Vermont Agency of Transportation
RECEIVED
CK'D BY M.E.M. OK'D BY C.W.M.
July 09, 2012
RESUBMIT APPROVED AS NOTED
BY C. CARLSON DATE 07-27-2012

PROJECT: VT RT 9, BRIDGE NO. 11
TOWN OF WOODFORD, VT
OVER WALDOOMSAC RIVER

TITLE: GIRDER 104G1

REFERENCE: PROJECT NO. ER BHF 010-1 (44)

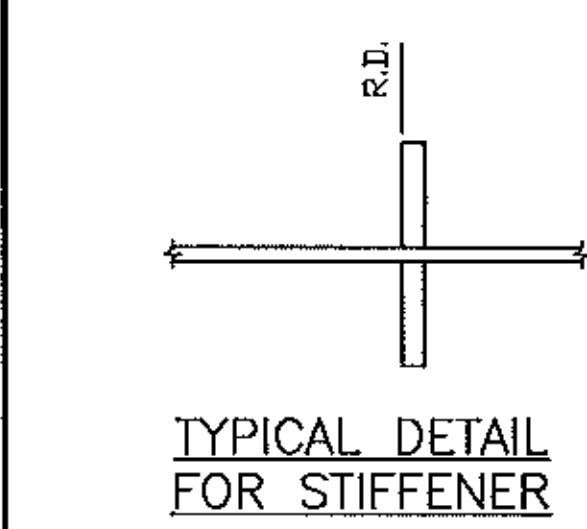
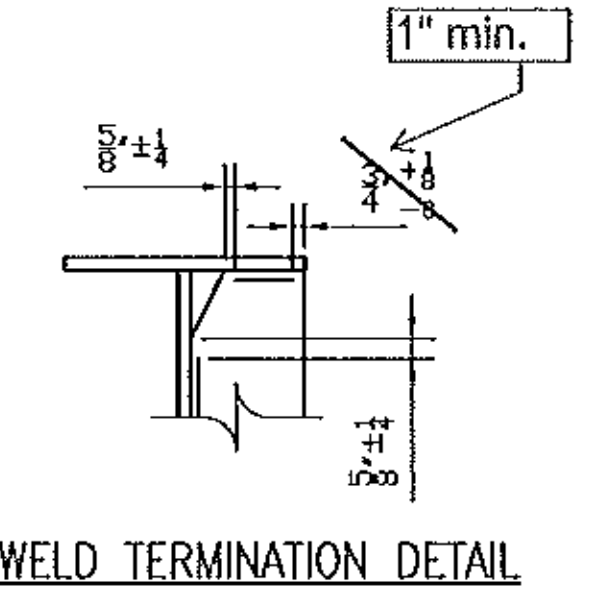
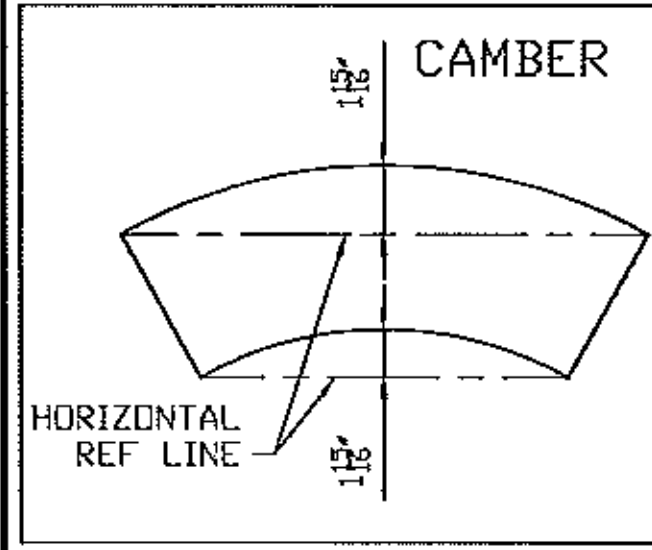
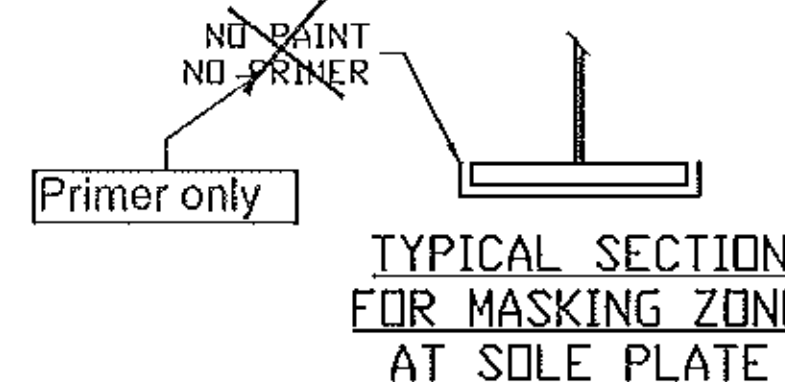
Is there room for WPS S-1001 with dart welder? There is only 5 3/4" between the two plates Typ. all girders.

THE FIELD SPLICE PLATES MUST NOT EXCEED THE END OF GIRDER

See standard specification 506.24(a)(9), no payment will be made for bolts, nuts, washers, they are considered to be incidental
